YARRA CITY COUNCIL
Internal Development Approvals Committee
Agenda

1.1	101-103 Queens Parade, Clifton Hill - PLN16/0751 - Use and development of the land for the construction of additional levels to the existing building, including partial demolition and a reduction in the car parking requirement.
------------	--

1. This report provides Council with an assessment of a planning permit application submitted for 101-103 Queens Parade, Clifton Hill. The report recommends approval of the application, subject to a number of conditions.

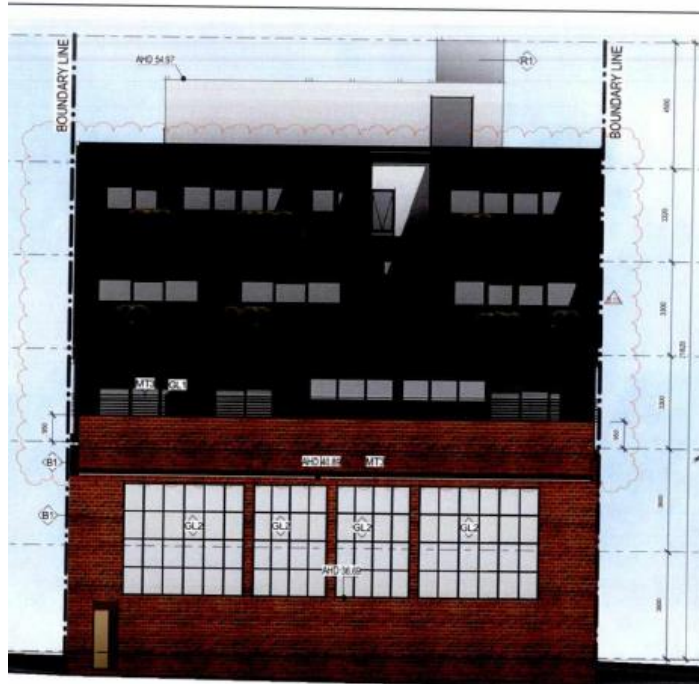
165. The proposed roof form for the new development will be flat. This design is acceptable given the contemporary nature of the proposal. Council's Heritage Advisor recommended using the opportunity of the proposed demolition of the existing roof to replace this structure with a skillion design, to reflect the original roof design of the heritage building. It was considered that this alteration had the added benefit of restricting the use of the existing section of roof, and thereby limiting views to any activity that may otherwise occur in this space. The proposal on how to reconstruct the roof is demonstrated in the diagram below.

Original southern elevation

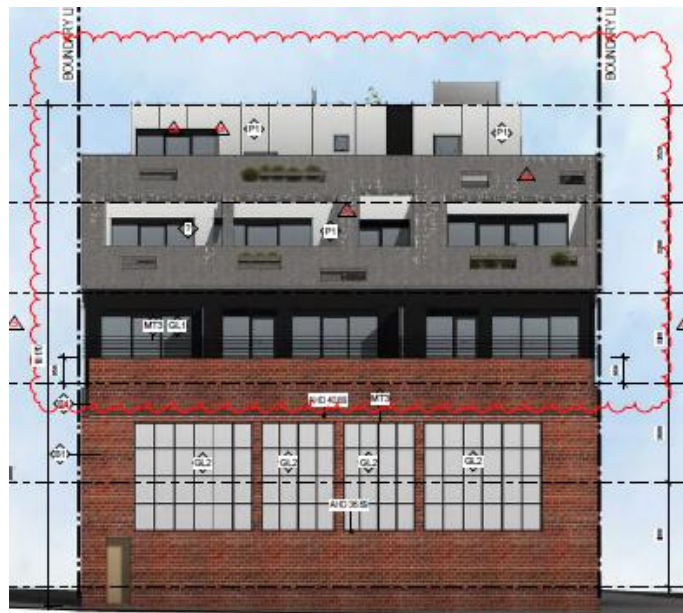
176. Based on the sketch plans dated 12 July 2017, the rear wall of Level 2 will be set back 8.3m from the southern boundary of the laneway, with the rear wall of Level 3 setback 10m from this location. These walls extend to respective heights of approximately 10m and 13m. To comply with this Standard, setbacks of 5.09m and 8.09m would be required. The setbacks provided comfortably meet these requirements, and if a planning permit is to issue, the changes to the rear setbacks can be required via conditions.

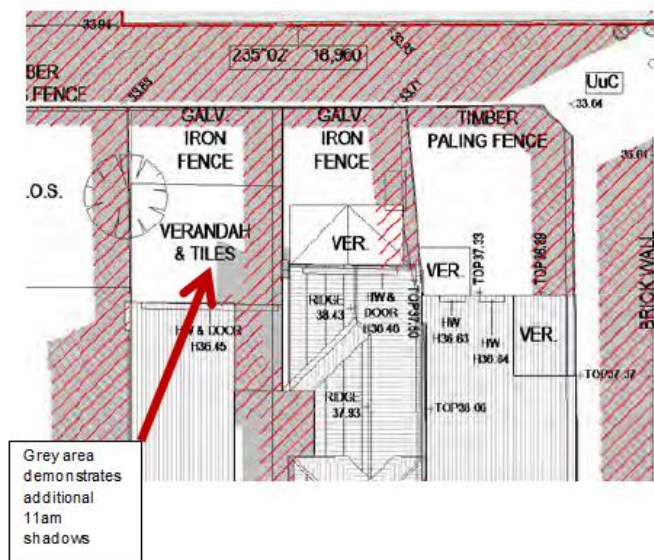
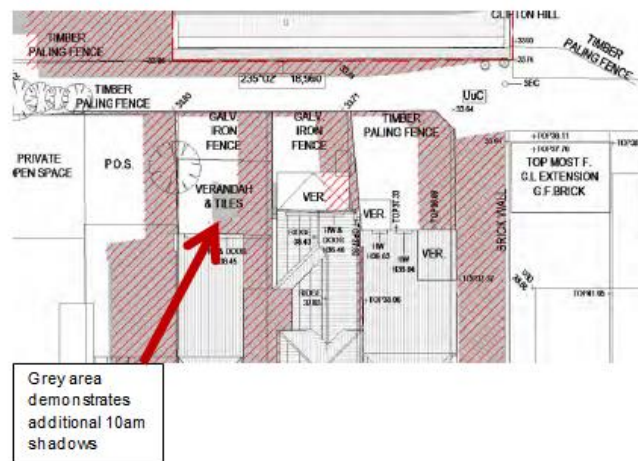
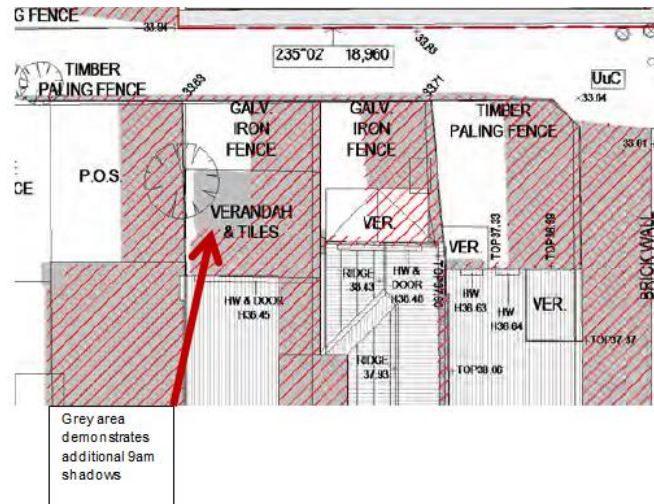
180. Whilst this wall is associated with the highest point of the development, the closest new wall to be constructed adjacent to these windows will be approximately 11m in height and associated with level 3. An 11m high wall would require a setback of 7.08m from the southern boundary to comply with the Standard. The 8.46m setback would comply. The respective distances between this wall and the adjacent windows would be 12.6m and 13m.

181. Given that Standard B20 (North-facing windows) is a more stringent test than Standard B19 (Daylight to existing windows), it is clear that the setbacks will comfortably comply with the latter. It is therefore considered that neither daylight nor direct solar access to habitable room windows within proximity to the development will be unreasonably compromised as a result of this proposal.

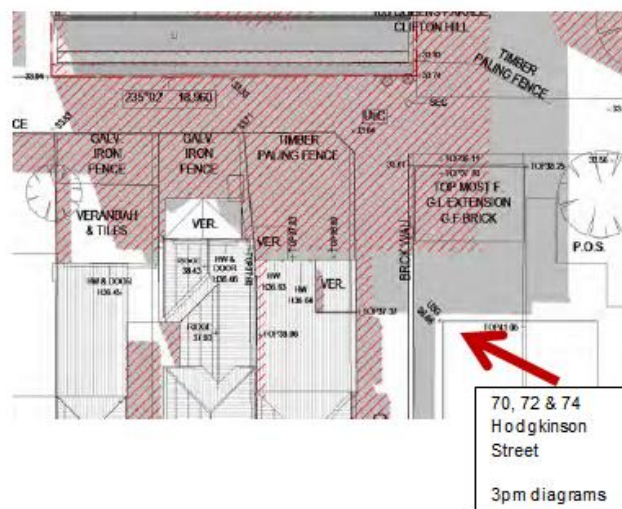
186. The only additional overshadowing that will occur in any of the adjacent areas of SPOS between 9am and 1pm will be limited to one site; 68 Hodgkinson Street. These additional shadows will be restricted to a small area at all times, with the most significant time being 9am. By 10am, only a marginal area of additional shadows will be cast, with no additional overshadowing within this space by midday. Given the limited degree of additional shadows occurring within this SPOS at 9am, 10am and 11am, this outcome is acceptable and is demonstrated in the shadow plans outlined below.

187. The plans indicate that there will be no additional overshadowing within any other sites until 3pm, with a small extent of further shadows affecting 70 and 72 Hodgkinson Street at this time. At 3pm, the shadow diagrams show that the entire area of SPOS within 74 Hodgkinson Street will be in shadow. It is noted that there is an existing outbuilding adjacent to the rear (northern) boundary of this property, which is approximately 4m high. Shadows cast by this outbuilding have not been portrayed; however it is expected that this would have shown that this area is already overshadowed at 3pm by the existing outbuilding. Irrespective of this, there will be no additional overshadowing affecting this space until 3pm. This outcome is acceptable.
188. The proposed 2pm shadows are shown below, which indicate that there will be negligible overshadowing within any southern sites at this time.

Attachment 3 - PLN16/0751 - 101-103 Queens Parade, Clifton Hill - Internal Urban Design comments

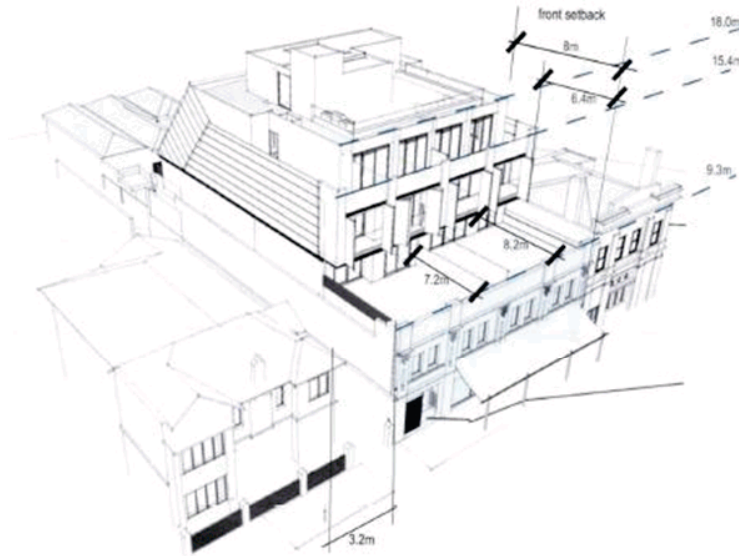
contributing to built form character; a generally fine grain site pattern with limited rear laneway access and narrow frontage widths; a predominantly two-storey street wall interspersed with one and three storey buildings.

The draft review proposes a 4 storey / 13m height limit for this precinct

Attachment 3 - PLN16/0751 - 101-103 Queens Parade, Clifton Hill - Internal Urban Design comments

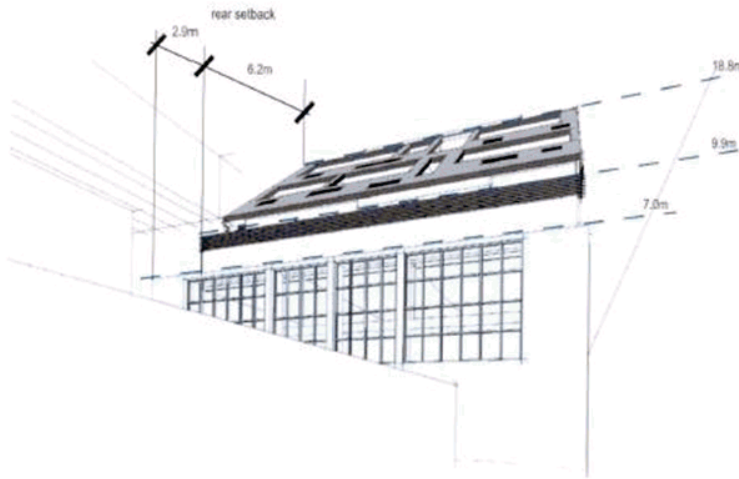
The rear façade of the proposal features a raking roof/wall treatment with inset balconies and recessed windows. This is a successful strategy in providing a transition in scale and reducing overshadowing to the single storey dwellings abutting to the rear on Hodgkinson Street. However, the view provided of the rear of the proposal from the Hodgkinson Street indicates that the massing strategy does reduce the impact of the development on the

residential streetscapes it will result in a significant increase in visual bulk behind the Hodgkinson Street residences when viewed from the street.

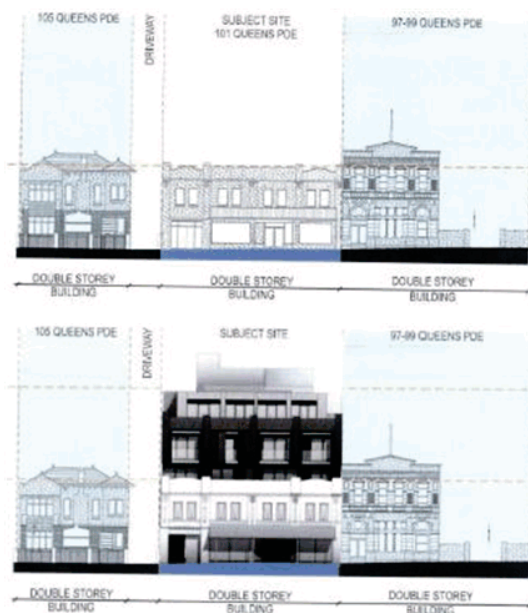
The existing streetscape façade is light coloured stucco render with cornices, pediments and pilasters rendered in the same colour and material. There is some signage for the commercial occupancies affixed to the building façade. The facades to the sides and rear are red brick with no ornamentation.

The proposed addition is clad in dark grey (gunmetal) perforated metallic cladding and screens with a lighter grey/silver metallic cladding to the 5th storey. The proposed 6th storey is rendered in a white material. The contrast in colour and tone is too great and the choice of such a dark colour for the upper storey addition increases the visual dominance of the addition in relation to the existing street façade. A more appropriate palette of materials/colours for the upper storey addition would include mid-greys, natural metals and brick or terracotta colours.
